Project: Sirius Building, 2-60 Cumberland Street, The Rocks

Date: 16 February 2021

RE: Air-cooled Chiller Noise Impact and Mitigation

Figure 1: Option 1: Pool Building Design

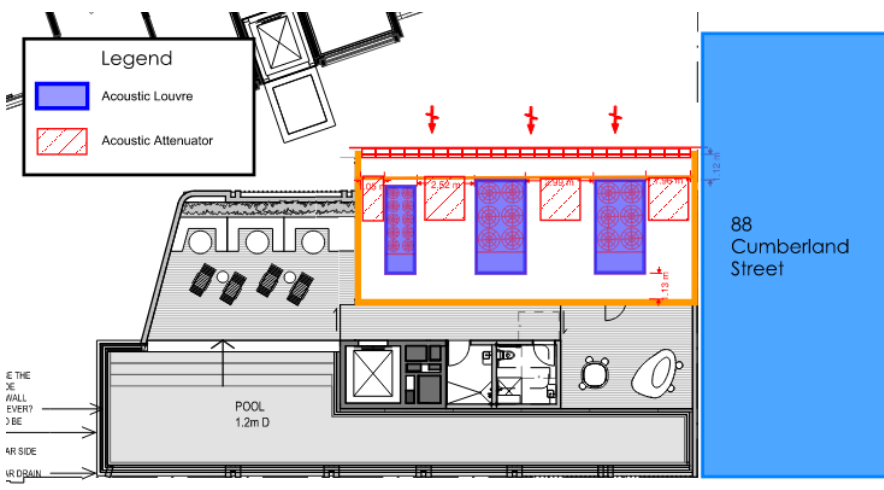
"A pool building located on the boundary also raises a number of significantly acoustic concerns for the both the current and future development potential of 88 Cumberland Street. A nil setback means pool activity and pool plant and equipment is located closer to our existing tenants. A nil setback would require Marks Henderson to inequitably provide a greater setback on our property in the event of redevelopment of our property."

For this design option, acoustic attenuators are proposed to attenuate noise emissions from air-cooled chillers at the intake interface of the plantroom, and acoustic louvres are proposed to attenuate discharge noise emissions from the air-cooled chillers. See Figure 1 for further information.
